Architect's Supplemental Instructions

Architect's Project No: 04561.01
Architect's ASI No: 040

Project:
Webster University
Interdisciplinary Science
Building

Date Issued: 12/09/2016

T0101.B

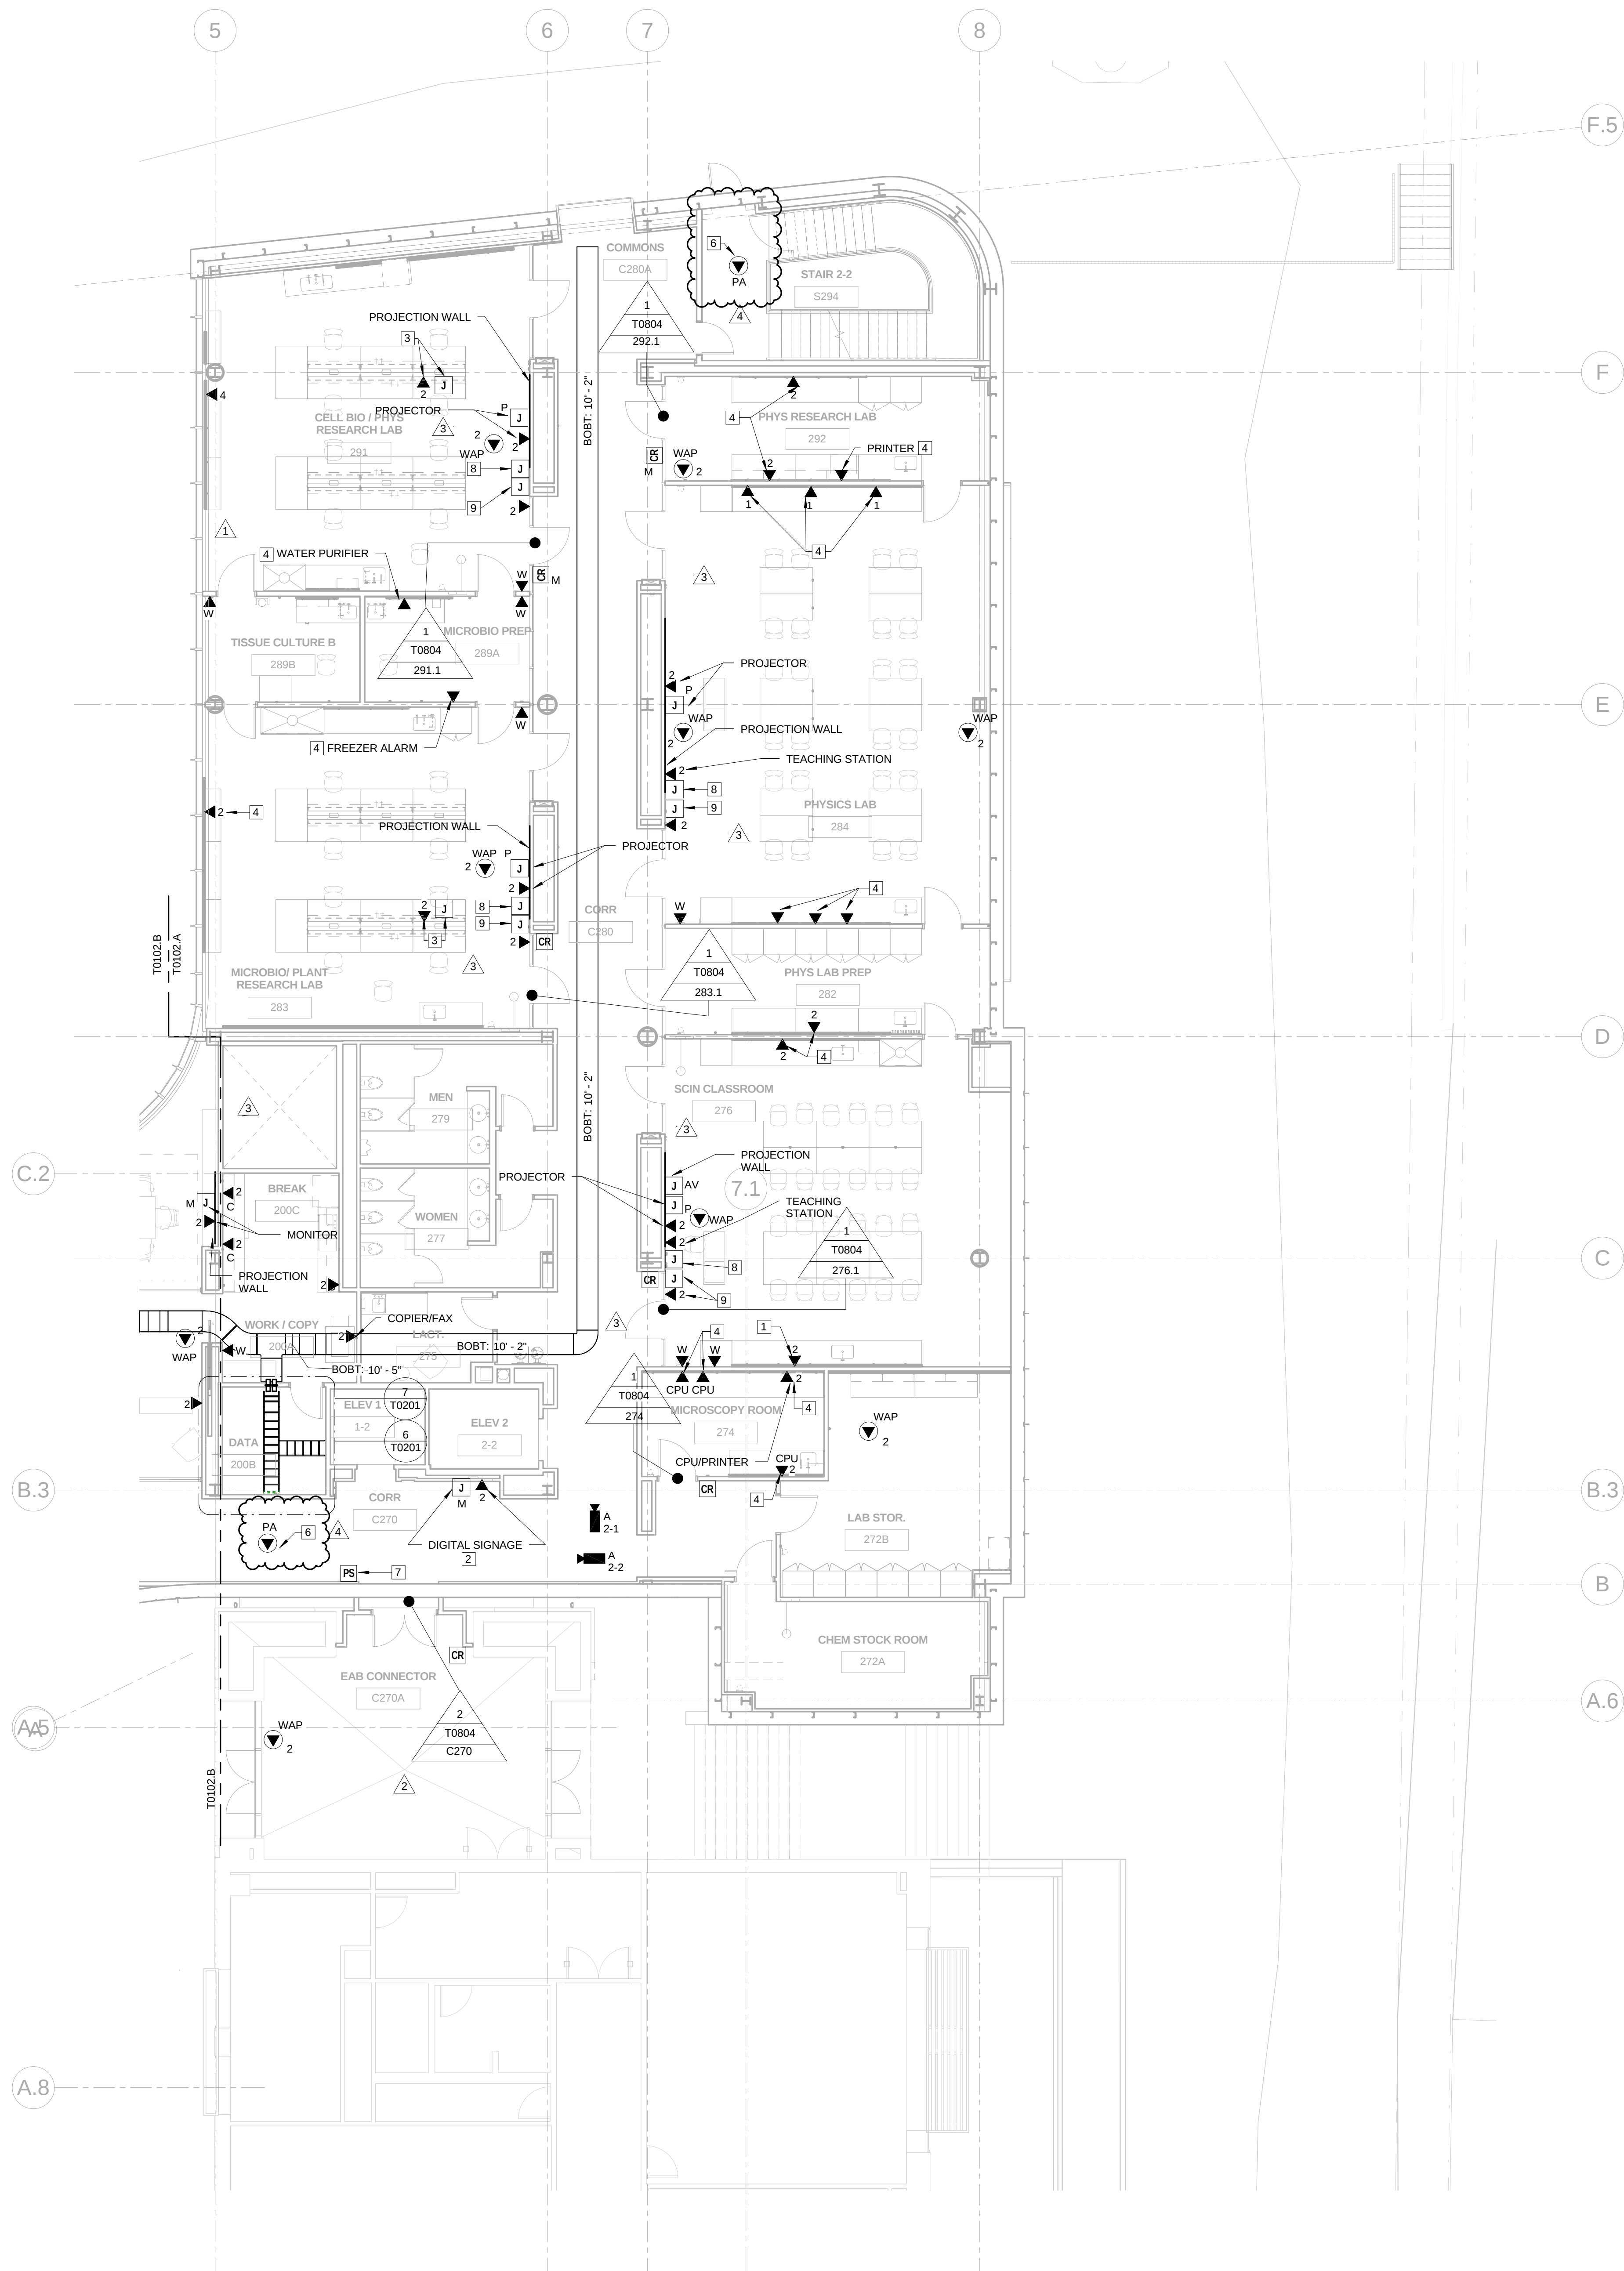
5. T0101.A – LEVEL 01 FLOOR PLAN – AREA B
 - A. Moved PA location from wall to ceiling.
 - B. Revised keyed note 13 to reflect this change.
6. T0101.B – LEVEL 01 FLOOR PLAN – AREA B

- A. Moved P.A. speaker from wall to pole. Added P.A. amplifier above ceiling.
 - B. Revised keyed notes to reflect these changes.
7. T0102.A – LEVEL 02 FLOOR PLAN – AREA B

- 21 PROVIDE 2#18 IN A 3" UNDERGROUND PVC CONDUIT FROM THE P.A. AMPLIFIER TO THE POLE MOUNTED P.A. SPEAKER. ROUTE CONDUIT AS DIRECT AS POSSIBLE. DO NOT EXCEED WIRE LENGTH OF 50'. MAKE FINAL TERMINATIONS AT BOTH ENDS.

- 22 P.A. AMPLIFIER (OFCI) MOUNTED ABOVE ACCESSIBLE CEILING ADJACENT TO CONDUIT STUB-UP (SEE KEYED NOTE 21).
- 23 PROVIDE A 1 1/2" CONDUIT NIPPLE FOR EACH VIDEO MONITOR THROUGH WALL FOR VIDEO WALL

- 24 OFCI OUTDOOR P.A. SPEAKER POLE MOUNTED AT 12'-0" ABOVE FINISHED GRADE TO THE SIDE SURFACE OF THE POLE. FIELD DRILL HOLE FOR CONDUCTOR CONNECTION TO THE SPEAKER (SEE KEYED NOTE 21). EXPOSED CONDUCTORS SHALL BE INSTALLED IN A LIQUIDTIGHT FLEXIBLE CONDUIT FROM THE POLE TO THE SPEAKER. PROVIDE A CONDUCTOR DRIP LOOP.

T0102.A

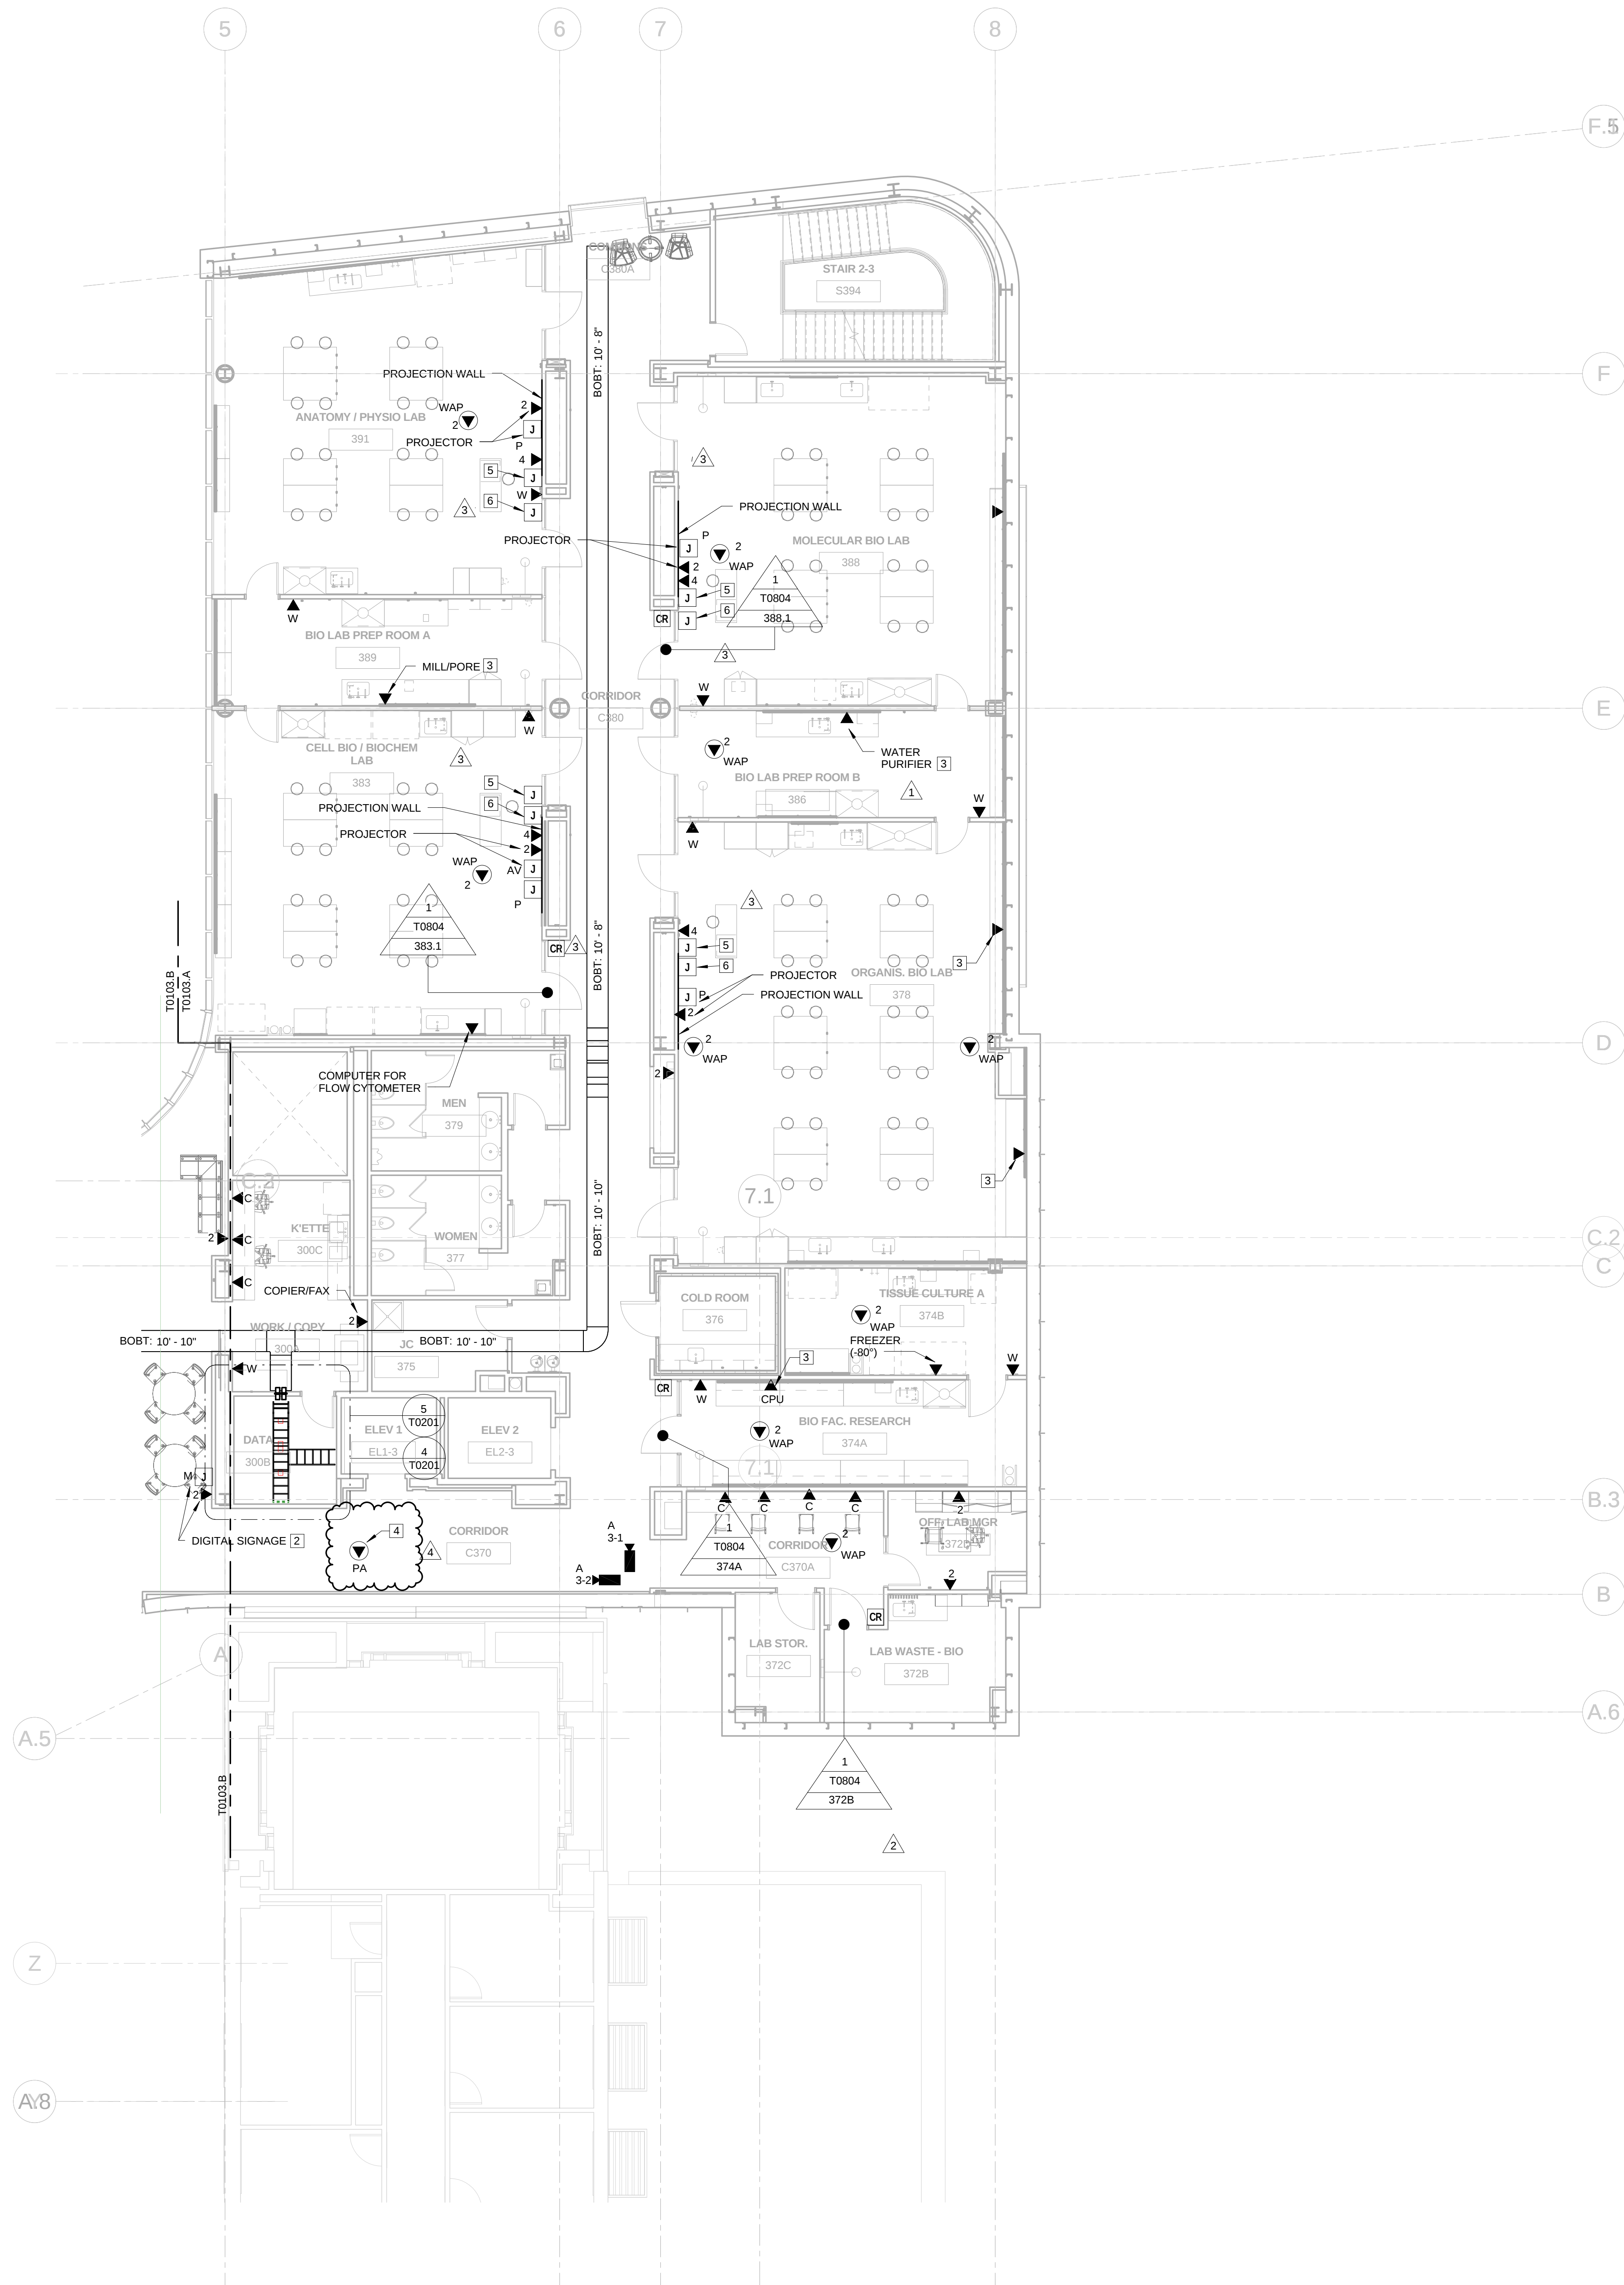
- A. Moved PA location from wall to ceiling.
 - B. Revised keyed note 6 to reflect this change.
8. T0103.A – LEVEL 03 FLOOR PLAN – AREA B

- 4 MOUNT IN COMMUNICATION CHANNEL OF 2 SECTION RACEWAY. SEE ELECTRICAL DRAWINGS FOR RACEWAY INFORMATION.
- 5 NOT USED
- 6 COORDINATE EXACT LOCATION WITH PA INSTALLER.
